Kelvin Henderson
Vice President
Catawba Nuclear Station

CNS-16-022

Subject: Supplemental Information to the Final Notification of Full Compliance with Order EA-12-049, "Order Modifying Licenses with Regard to Requirements for Mitigation Strategies for Beyond Design Basis External Events" and with Order EA-12-051, "Order to Modify Licenses With Regard To Reliable Spent Fuel Pool Instrumentation" for Catawba Nuclear Station

CNS RESPONSE TO REQUEST FOR ADDITIONAL INFORMATION REGARDING THE OVERALL INTEGRATED PLAN FOR IMPLEMENTATION OF ORDER EA-12-051, RELIABLE SPENT FUEL POOL INSTRUMENTATION

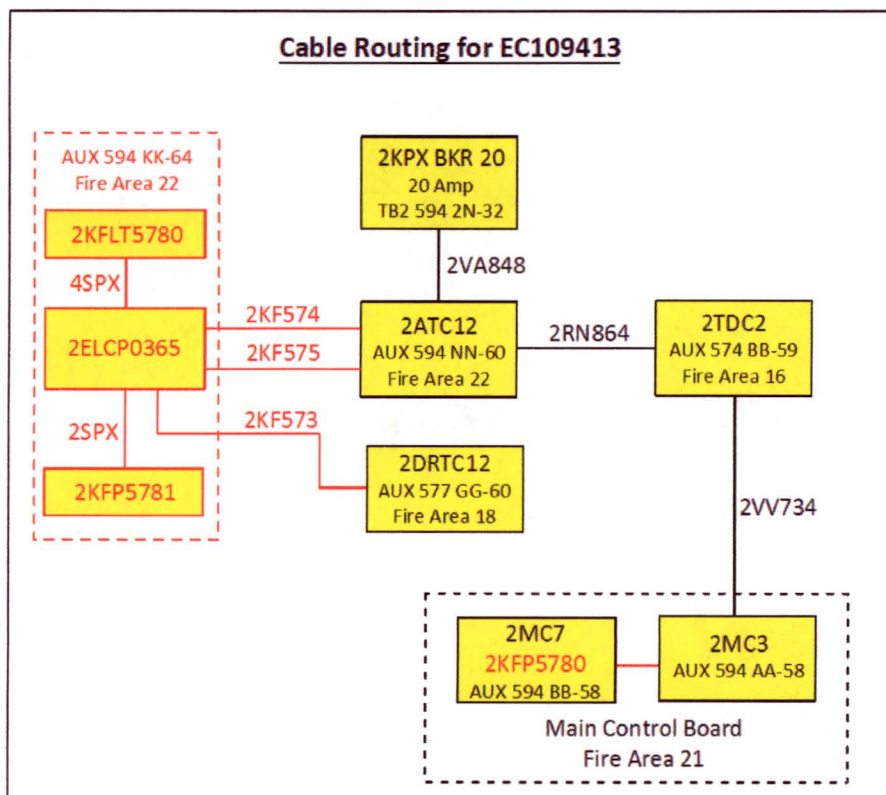
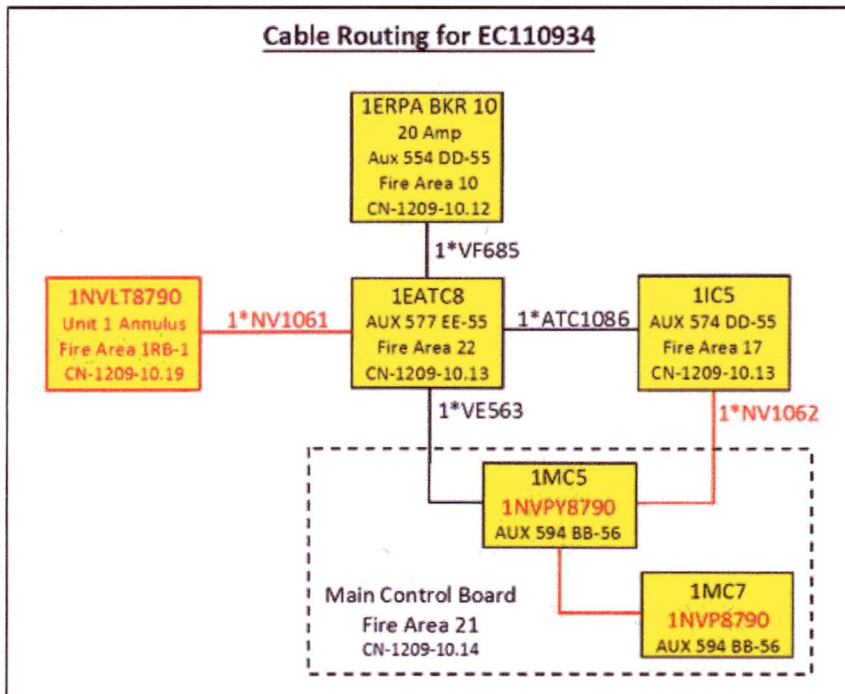
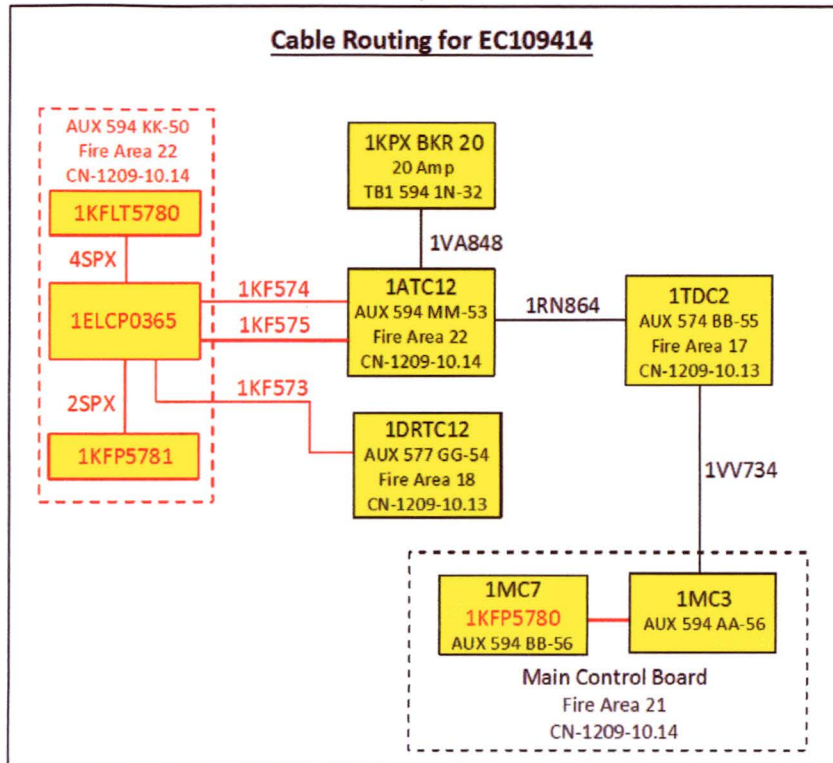
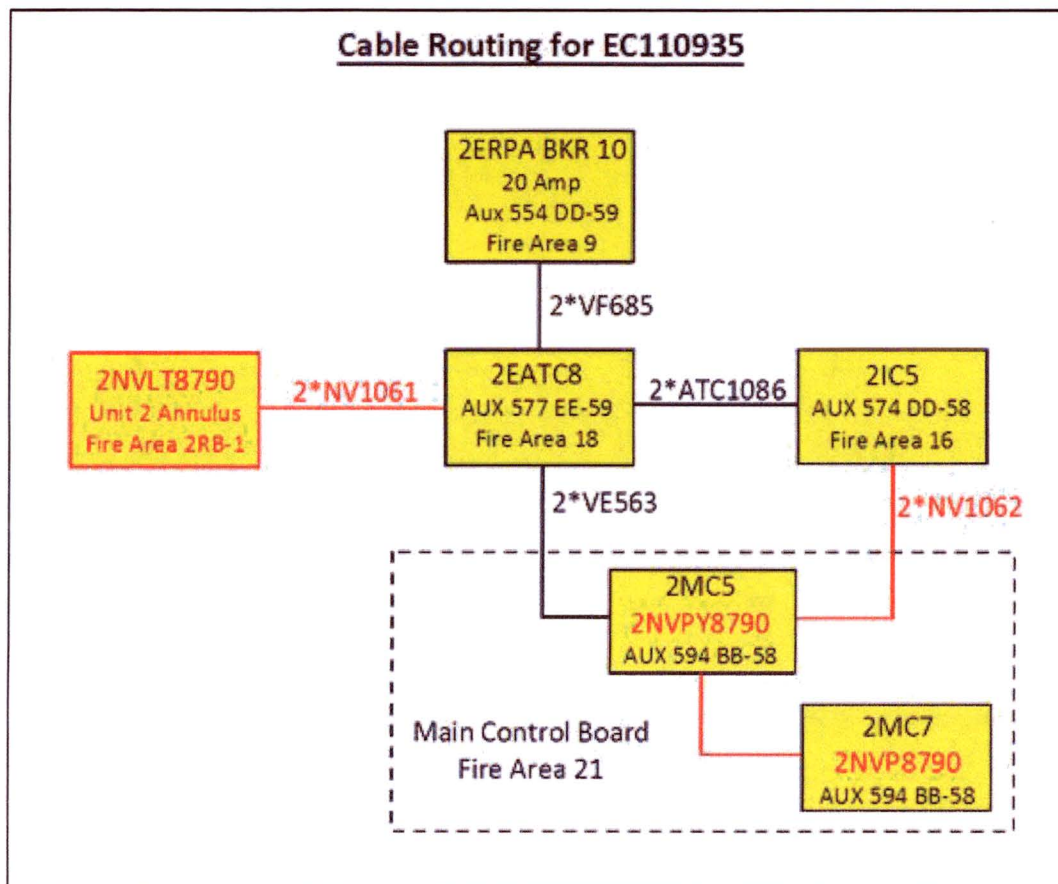
RAI-3

Please provide additional information describing how the final arrangement of the SFP instrumentation and routing of the cabling between the level instruments, the electronics and the displays, meets the Order requirement to arrange the SFP level instrument channels in a manner that provides reasonable protection of the level indication function against missiles that may result from damage to the structure over the SFP. If applicable, please describe what precautions will be taken to ensure the back-up instrument's sensing line slope requirements will be maintained and that it does not become susceptible to freezing during cold outside temperatures. Also describe the arrangement provisions regarding how the back-up transmitter will be accessible for periodic calibration and maintenance.

The primary (1/2KFLT5780) Spent Fuel Pool Level Monitor horn assembly is installed in the Spent Fuel Building, which is a Seismic Category 1 structure. This structure rating includes design for protection against external missiles. The back-up (1/2NVLT8790) level monitor transmitter is located in the Reactor Building Annulus area, which is also a Seismic Category 1 structure. Any event that causes damage to the structure over the SFP cannot affect the back-up channel, which has no components or cabling located in the Spent Fuel Building.

The wide range primary Spent Fuel Pool Level Monitor transmitter is located at the 594 Elevation of the Auxiliary Building. This primary channel is non safety related and all associated cabling is installed in non safety cable trays. 120 VAC control power for this monitor is provided from a plant power panel board, also on Elevation 594 of the Auxiliary Building. Cables are routed from the power panel board to the power control panel adjacent to the transmitter and from the power control panel to the Control Room display. (See the circuit route below from the EC package Fire Protection Forms). Circuits shown in BLACK are existing circuits, circuits shown in RED are NEW and were installed as part of the Engineering Change package.

The wide range back-up Spent Fuel Pool Level Monitor transmitter is located at the 557 foot elevation per drawing CN-1499-01.10-00 for Unit 1 and at elevation 556 per drawing CN-2499-01.10-00 for Unit 2 in the Reactor Building Annulus. This back-up channel is Nuclear Safety Related and all cabling is installed in safety related cable trays. Circuitry associated with this transmitter is provided with 120 VAC power from a Vital I&C inverter panel board 1(2)EATC8 on the 554 elevation (See the circuit route below from the EC package Fire Protection Forms). Circuits shown in BLACK are existing circuits, circuits shown in RED are NEW and were installed as part of the Engineering Change package. As stated above, the back-up monitor is classified as Nuclear Safety Related and the sensing line tubing is also classified as Nuclear Safety Related. The tubing is about 35 feet in length and is sloped downward a minimum of ¼" per foot from the process tap.

Tubing is installed in accordance with all applicable Nuclear Safety Related guidance, which includes the following: design document CICS-A-20.02, installation procedure SI/0/A/5090/001 (Tube Fitting and Tubing Installation), specification CNS-1206.00-04-0002 (Support Criteria for

Construction Tubing Slope), IP/0/A/3850/006 (Controlling Procedure for Installation of Tube Supports) and specification CNS-1206.00-04-006 (Civil Specification, Routing and Support of Tubing).

An analysis of ELAP temperatures in areas adjacent to the annulus shows that the lower annulus area should not be subject to freezing during cold outside temperatures. There are a number of transmitters associated with different plant systems currently located in the lower annulus area. Most of these devices are routinely accessed for calibration and maintenance. The pressure transmitter for Spent Fuel Pool Level will also be accessible, as needed.

APPENDIX D: SEISMIC REQUIRED RESPONSE SPECTRA VEGAPULS 62 ER

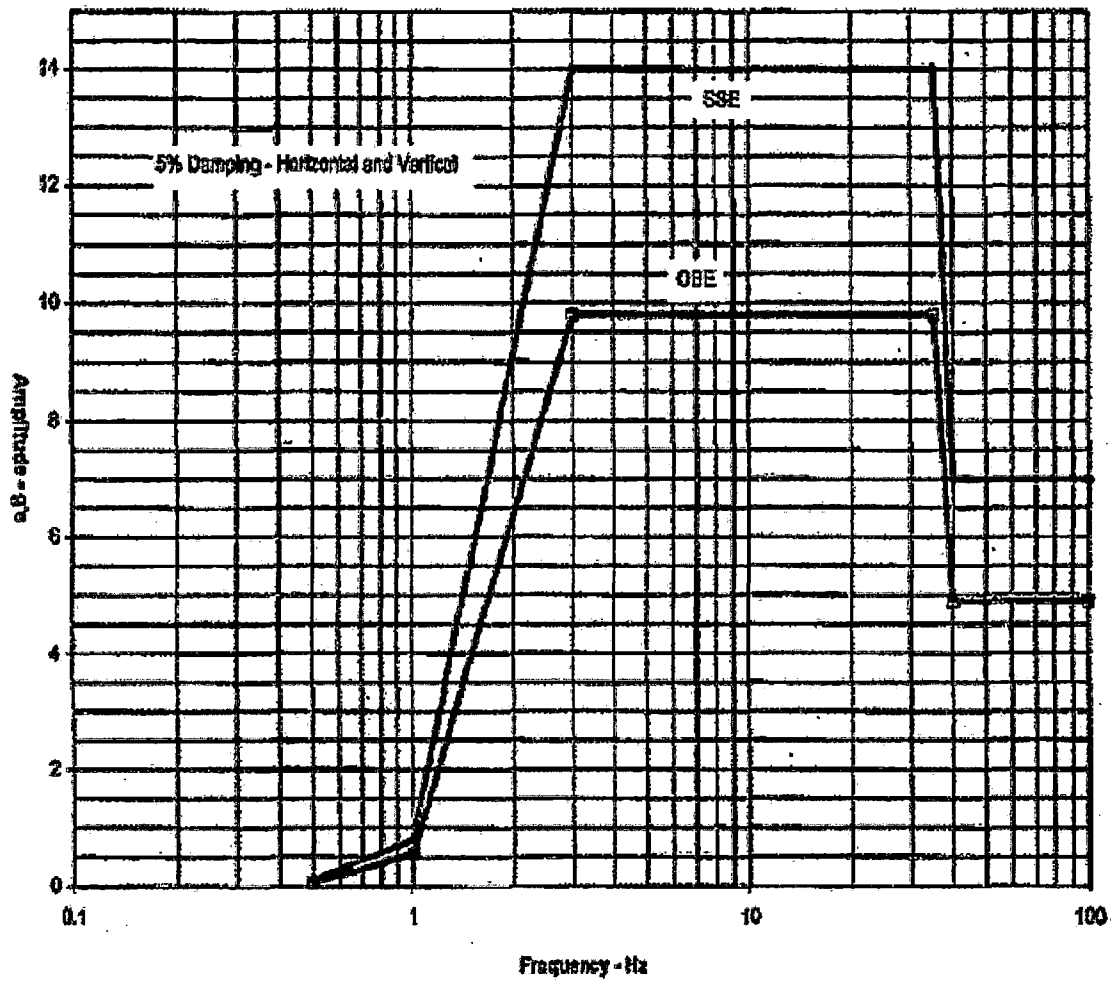
RAI-8

For RAI # 7 above, please provide the results for the selected methods, tests and analyses used to demonstrate the qualification and reliability of the installed equipment in accordance with the Order requirements.

The sensor, local indicator, power control panel, horn end of the waveguide, standard pool end, sensor end mounting brackets and waveguide piping were successfully seismically tested in accordance with the requirements of IEEE Standard 344-2004 (CNM-1336.04-0029.001 - Areva document 51-9202556-005). The system was monitored for operability before and after the resonance search and seismic tests. The required response spectra used for the five Operating Basis Earthquakes (OBE) and one Safe Shutdown Earthquake (SSE) in the test were taken from EPRI TR-107330. The EPRI RRS profile is included below. This test level exceeds the building response spectra where equipment is located. Intermediate mounting brackets for the waveguide piping and mounting for the power control panel/terminal box is designed in accordance with the site specific standards for seismically mounted equipment and pipe supports per Seismic Category II criteria. The back-up level channel determines SFP water level with a Nuclear Safety Related Rosemount Model 3154N differential pressure transmitter. Other components in the instrumentation loop are an Acopian Model VB35GT10 power supply and a Weschler Model VX-252 panel indicator. Below is information on these components from the engineering change package reference documents.

It should be noted that the test spectrum for the Areva equipment is not identical to the EPRI RRS profile (compare Figure 4 and Appendix D figures shown below).

"In the test of the VEGAPULS 62 ER, the seismic required response spectra {RRS} used for the testing was in accordance with the RRS curve from EPRI TR-107330 [7] at 5% damping {see Appendix D}. This RRS is intended to envelop not only the seismic level for items mounted to building structure, but also the much higher levels that can be experienced for items mounted in or on cabinets due to the additional seismic amplification from cabinet resonances. The results of the seismic test described above are reported in reference [8]".
